**KANEPACKAGE PHILIPPINE INC.**

INVESTIGATION REPORT FORM (IRF)

Customer	BROTHER INDUSTRIES PHILIPPINES, INC.	Attention To	REXEL ALMARIO
Item Code	D037M5001.C1	Department	PRODUCTION
Item Description	CARTON DCP-J131DW EU-C; A	Date of Detection	250811
Job Order Number	JO25-M-02513-12A	Section Detected	QA SCREENING

ILLUSTRATION OF THE PROBLEM

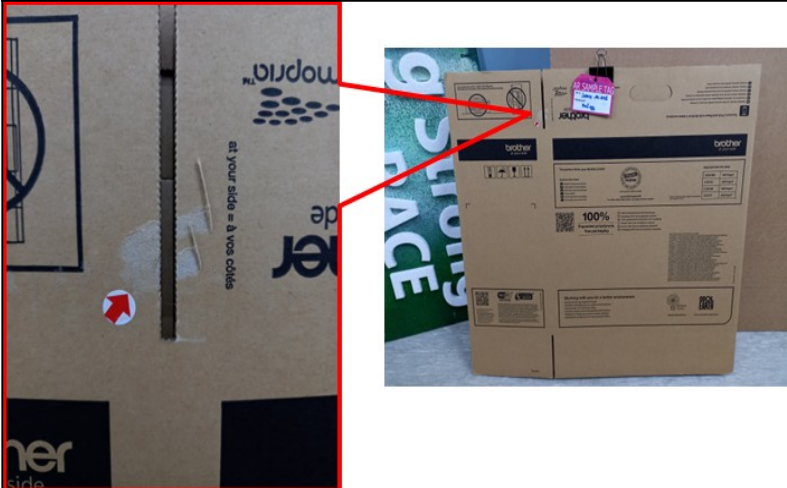
Nature of Defect:

PEEL OFF

Requirement:

NO PEEL OFF

Actual

WITH PEEL OFF

WHY 1 : Peel Off occurs during auto stripping in Diecut S1700

WHY 2 : Presence of uncut liner

WHY 3 : Backward movement of cutting blade

WHY 4 : Loosed blade on the slot portion

WHY 5 : Due to hard materials (NPK280) the 2 bridge on the slot portion got insufficient

WHY 1: Replacement of die blade (with attachment of special r nstruction regarding additional bridge on the slot portion)
